REF: SUP25-0023
DATE: August 14, 2025

| Request | - | Amendment to Special Use Permit, Originally Granted by Ord.143-24, for Polish Cultural Center |
| Location | - | 1600 Mott Avenue (parcel #1627991) |

SPECIAL USE PERMIT
TOLEDO CITY PLAN COMMISSION
REF: SUP25-0023
DATE: August 14, 2025
TIME: 2:00 P.M.

ELEVATIONS

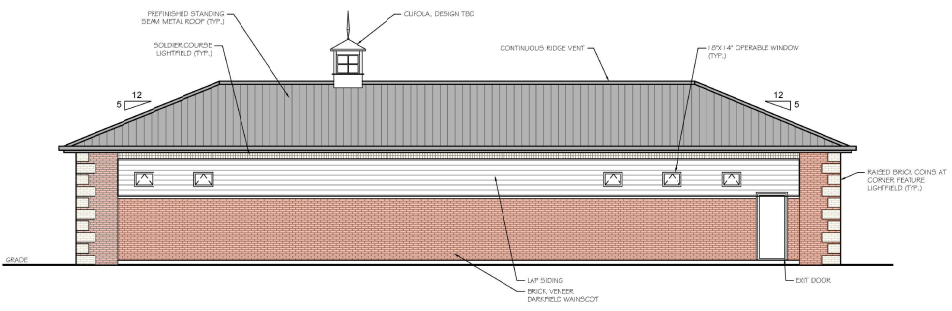
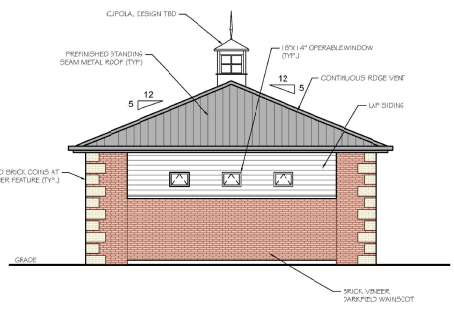
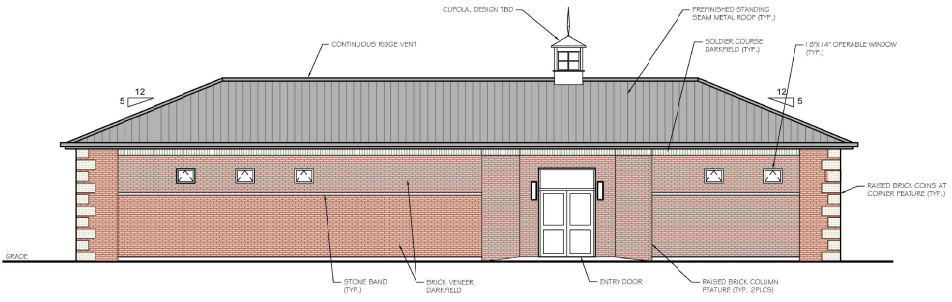
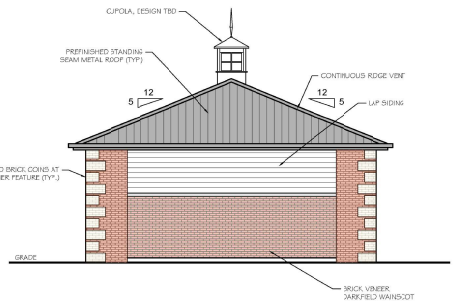
The proposed building elevations are comprised of brick veneer and wood-lap siding. The proposed brick is classified as "predominant materials" and the wood-lap siding is classified as an "accent material" per TMC§1109.0500 – *Building Façade Materials and Color*. In order to adhere to this code section, predominant materials must consist of at least 80% of each elevation and only up to 20% of each elevation may be comprised of accent materials. The south elevation meets these thresholds however, the remaining three (3) elevations do not meet the predominant material threshold and exceeds the accent materials permitted. Revised elevations must depict material types and percentages that are in conformance with TMC§1109.0500, and is listed as a condition of approval.

- j. The location, lighting, and size of any signs.
37. Any future proposed signage must meet the requirements of *TMC§1113 - Signs*.
38. Building elevations shall be of quality materials as stated in TMC§1109.0500. **Not acceptable as depicted, as accent materials proposed surpass 20% of each elevation. Revised elevations must be submitted depicting material types and percentages that are in conformance with TMC§1109.0500.**
